DO - No. EASA.21J.020	Service Letter SL 82	Original Issue
--------------------------	---------------------------------	----------------

Instructions for grounding of non-insulated electrically controlled governor

Type Affected: P-853-16, P-877-16 (Electr. contr. governors with non-insulated head)

Fig. 2

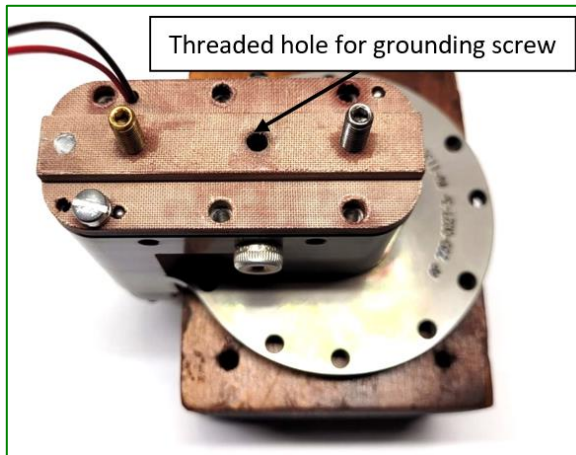
1. Remove cover 220-0090-5 (item 6.10) acc. to Overhaul Manual E-1049 (chapter 6.3).
2. If the cover doesn't have threaded hole for the grounding screw (see fig. 2), exchange it by cover with the threaded hole. Optional drill a thread 10-32UNF according to fig.3

3. Install the screw with spring 220-0144-5-2 in the hole for the grounding screw (fig. 2).
4. The screw should be approx. 5.5 mm (0.217 inch) below the bottom of the cover (fig. 4), to ensure the spring makes contact with the lever.
5. Assemble the cover to control head, see fig. 6.
6. Install larger eye of the cable to the grounding screw and tighten with DIN439B-M5-A2 nut.
7. Install the smaller eye of the cable below the screw 6.24 that is used for grounding (fig. 5).
8. Fix the wiring in place acc. to manual E-1049 (chapter 11.3).
